Mid-Canal Storage Project (PROJECT)
MITIGATED NEGATIVE DECLARATION (MND)
SCH# 2022120628

Notice of Completion & Environmental Document Transmittal
Mid-Canal Storage Project
SCH# 2020060267
Riverside County

11- IMP-111
PM 46.939
Mid-Canal Storage Project
MND/SCH# 2022120628

SUBJECT: NOI to Adopt an MND for the CVWD Mid-Canal Storage Project

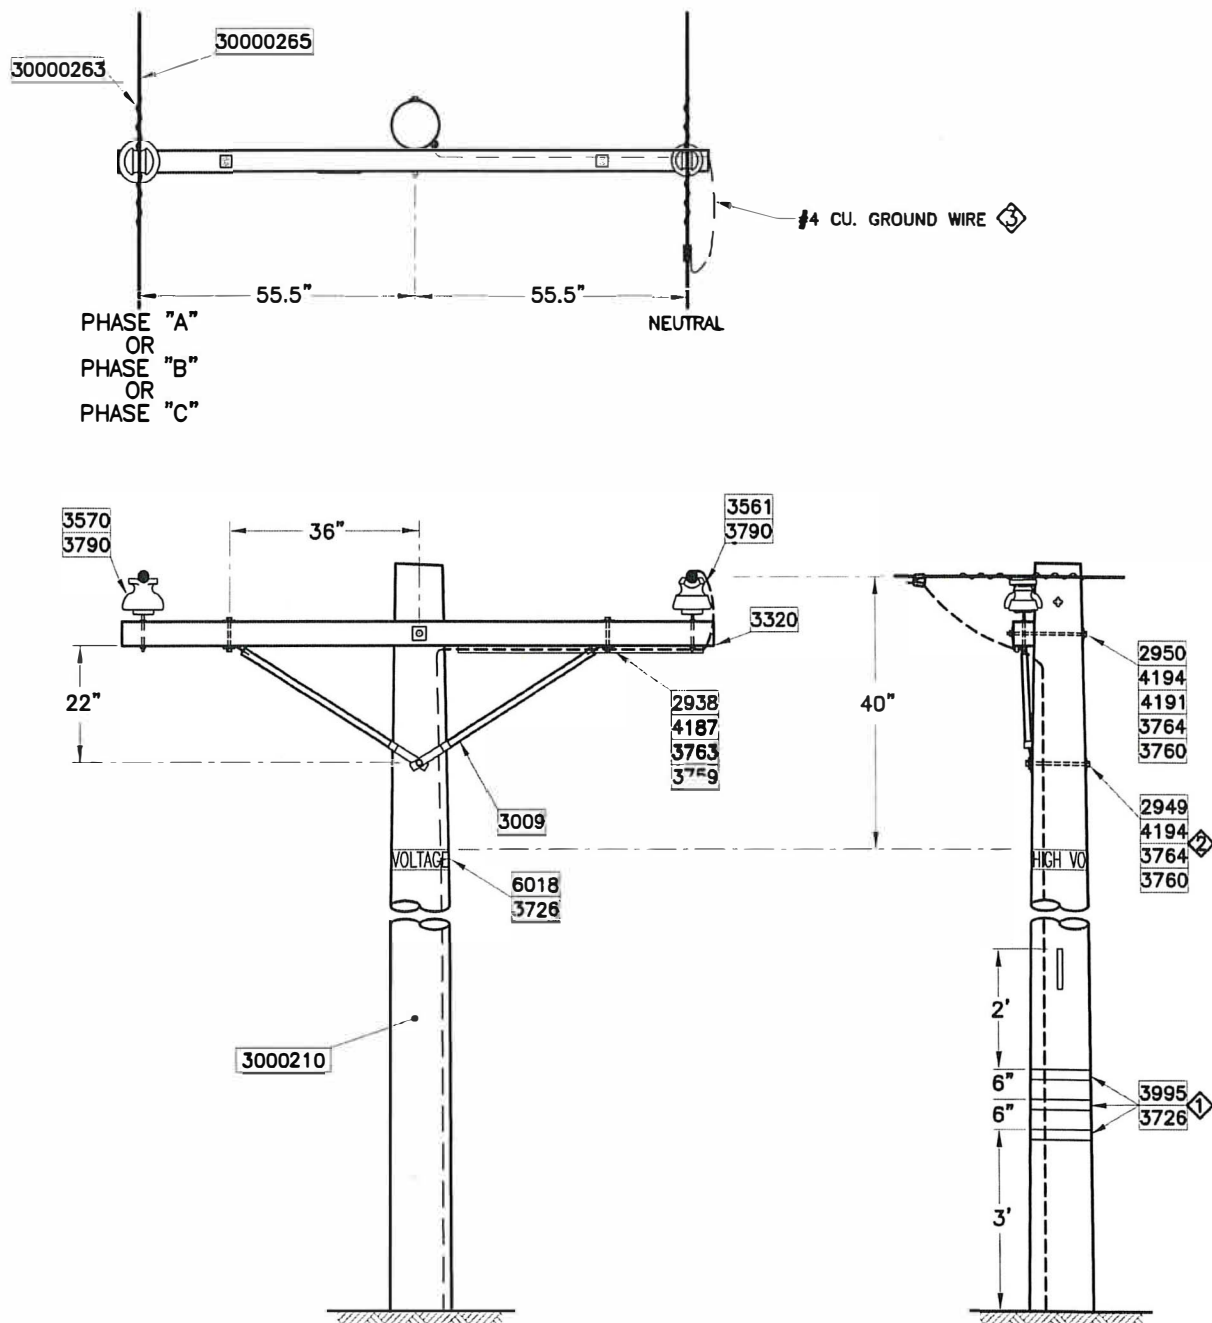
New single-phase primary line extension would need to cross under the IID's existing "KN&KS" 230kV and "N" 161kV transmission lines and proceed in a north westerly direction along the north side of the Coachella Canal Road right of way.

IMPERIAL IRRIGATION DISTRICT		
DRAWN BY	<i>JD</i>	 <div> <div>30000000</div> <div>GUY, DOWN, LD</div> </div>
REVIEWED		
APPROVED	<i>AK</i>	
REVISION	REV 04	
DATE	9-2-2016	210.10

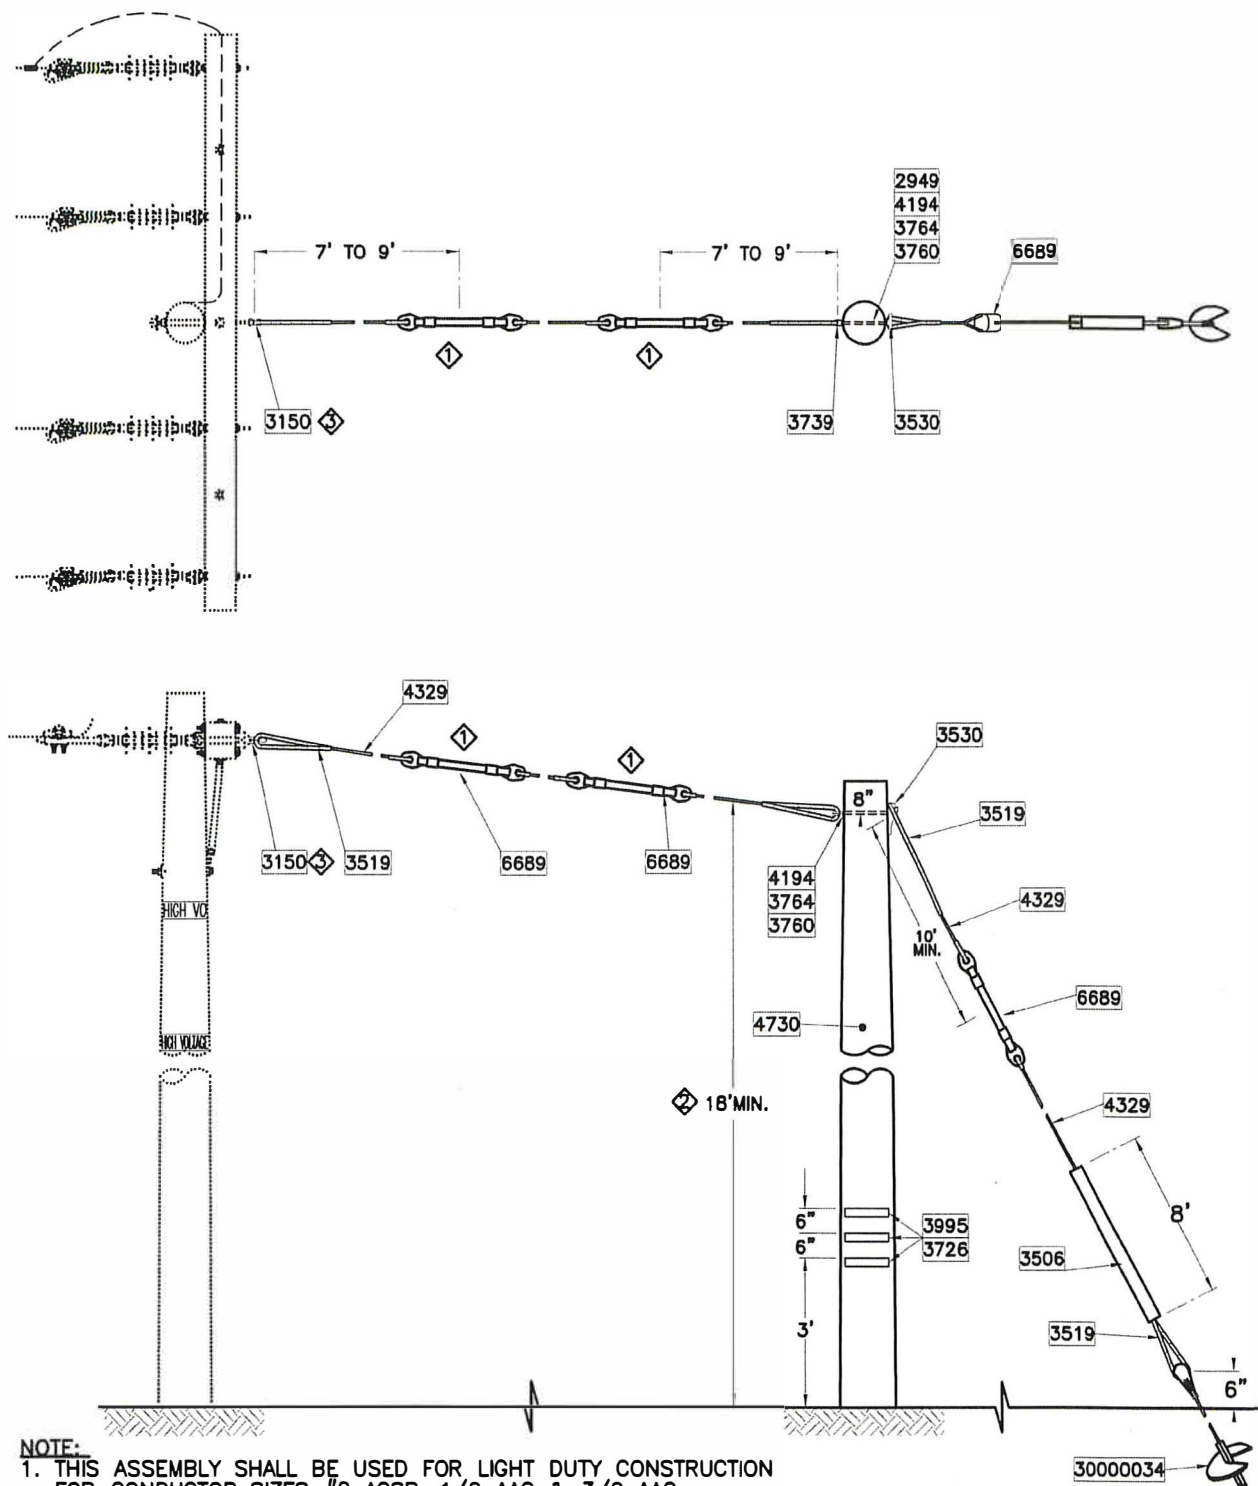
Please see attached photo of intersection with IID transmission lines and overhead single-phase primary pole standard details, that include guying, head guy pole guying and customer meter pole detail.
